Re: Pio Pico Energy Center Project (11-AFC-01)
Application for Certification Refinement - Enhanced Water Treatment System

APPLICATION FOR CERTIFICATION
FOR THE *PIO PICO ENERGY CENTER, LLC*

Docket No. 11-AFC-1
PROOF OF SERVICE
(Revised 5/15111)

FIGURE 3.5-5 (REVISED)
FIRE PROTECTION SYSTEM

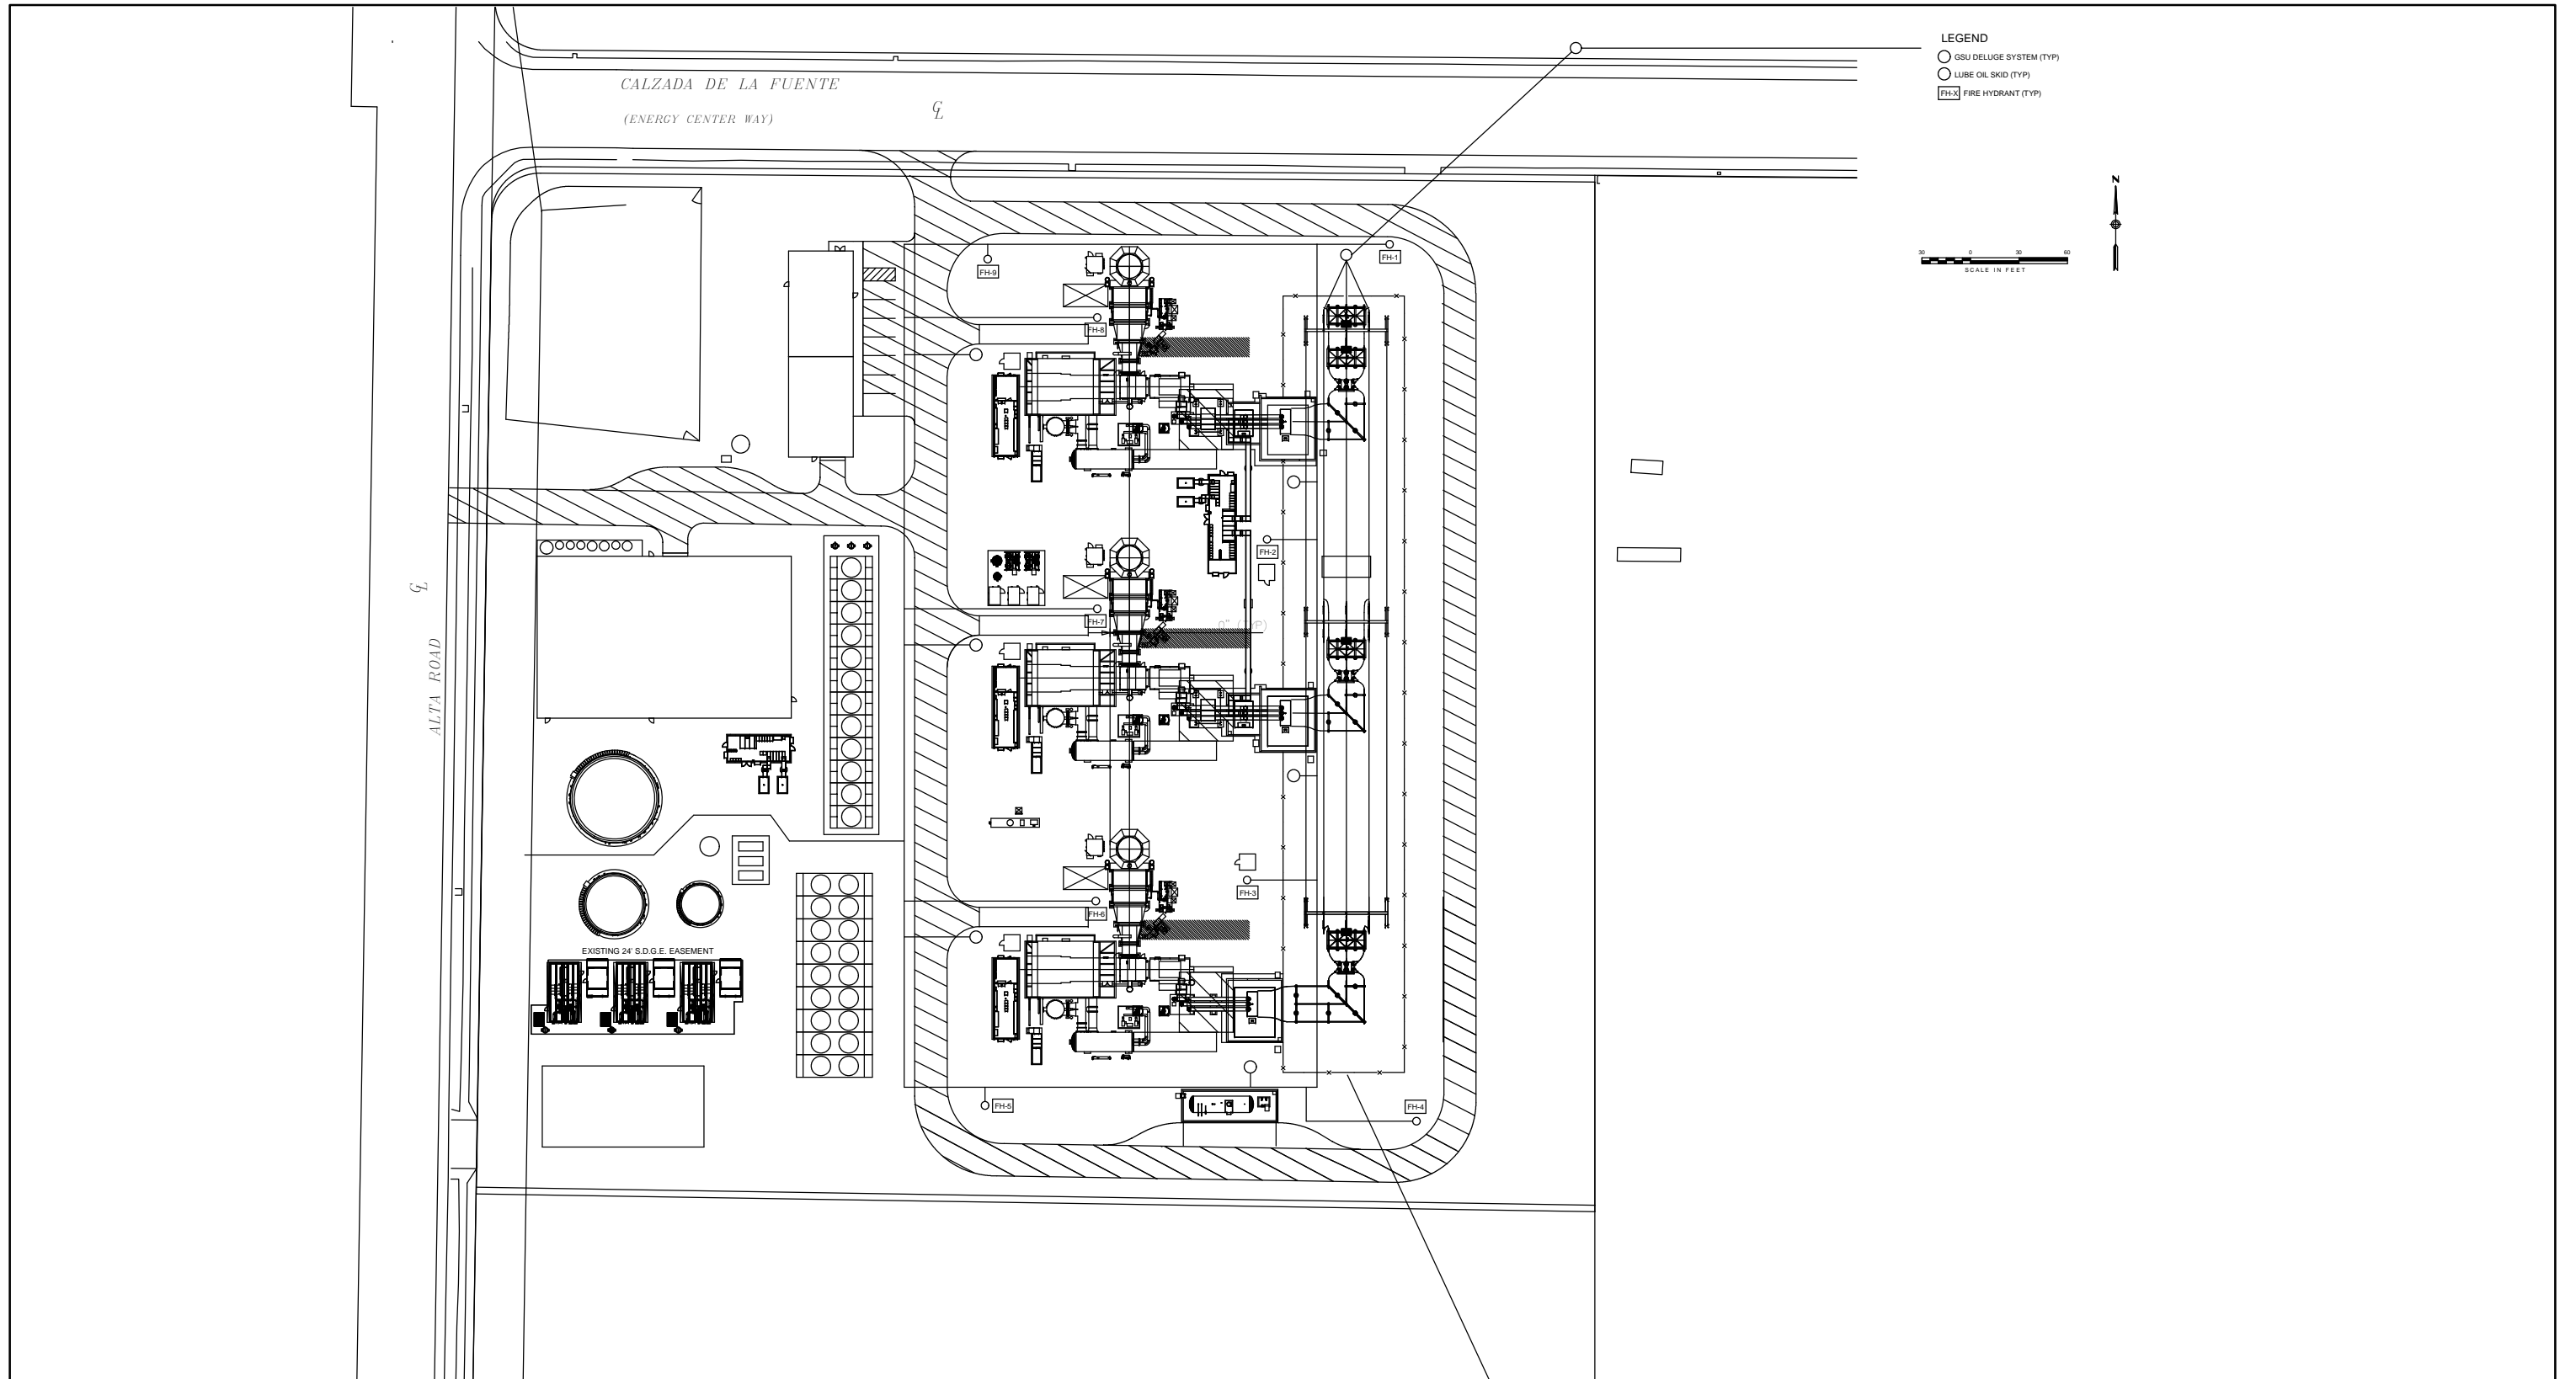
The fire protection system has been updated to feed directly from the local OWD system in Alta Road. Revised Figure 3.5-5, Fire Protection System, is provided in this AFC Refinement to reflect the changes to the western portion of the site resulting from the EWT System.

REVISED FIGURE 5.11-9

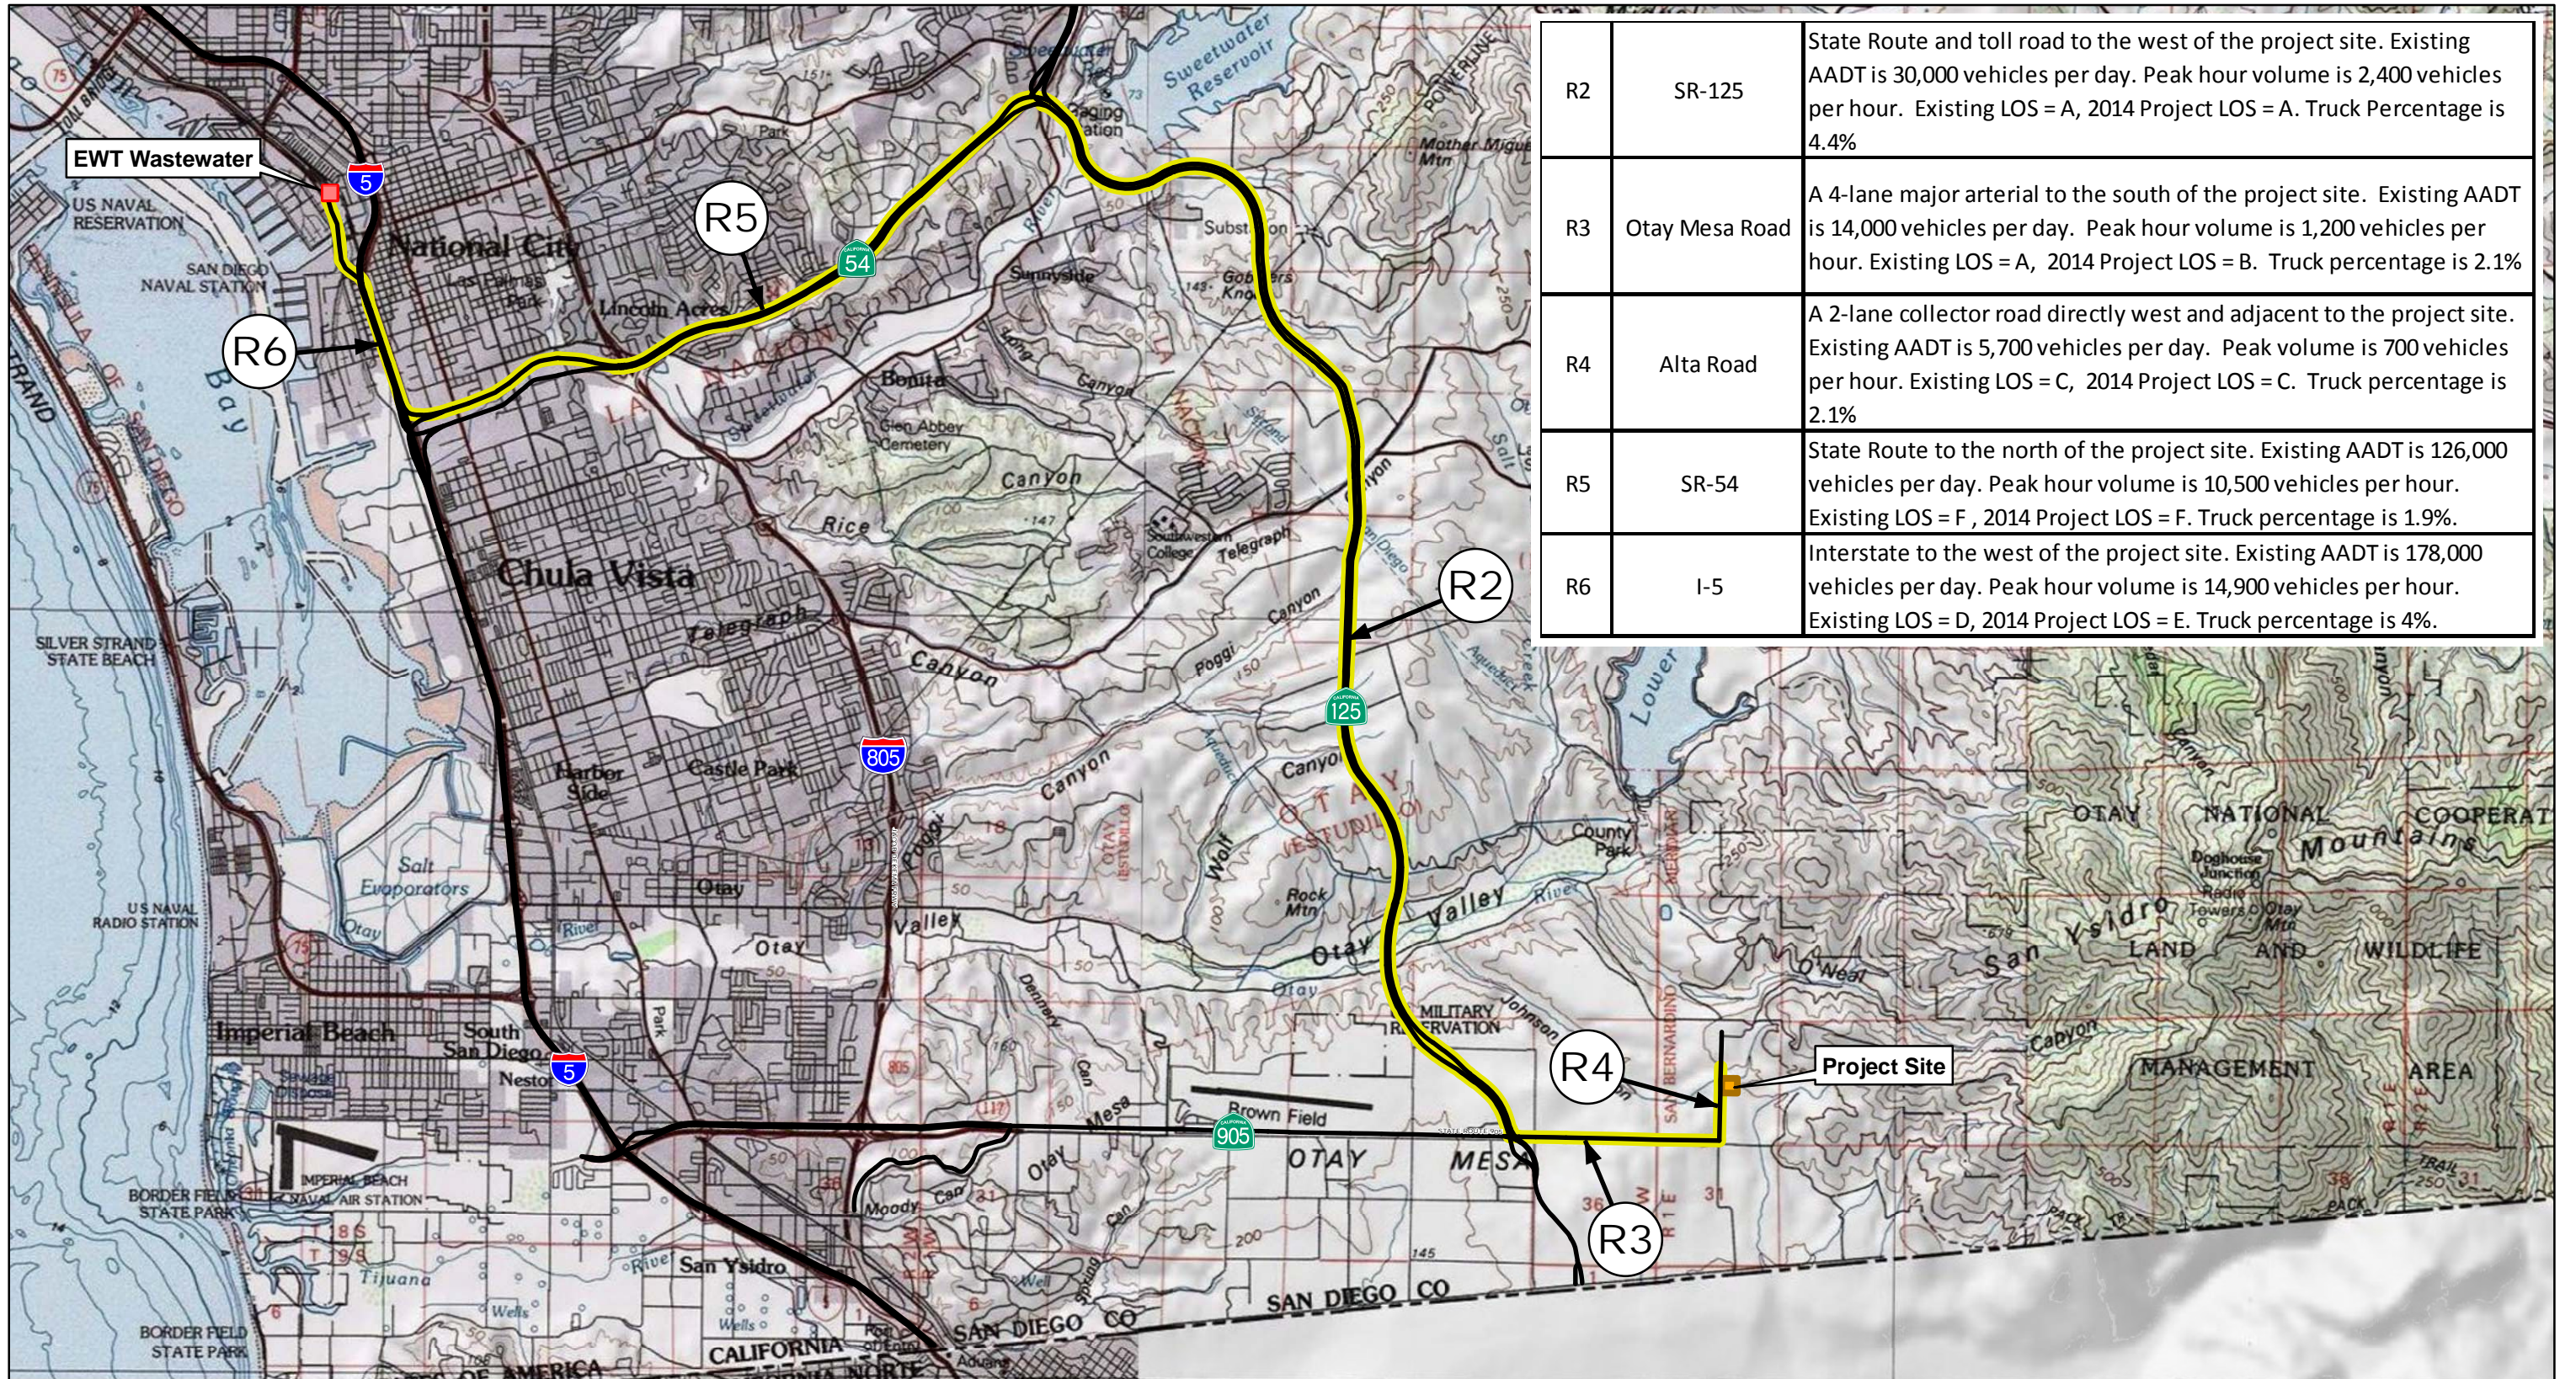
This scenario includes Year 2014 No Project traffic volumes plus PPEC project operations trip generation. Revised Figure 5.11-9 shows Year 2014 Project Operations peak-hour traffic volumes at the project study intersections.
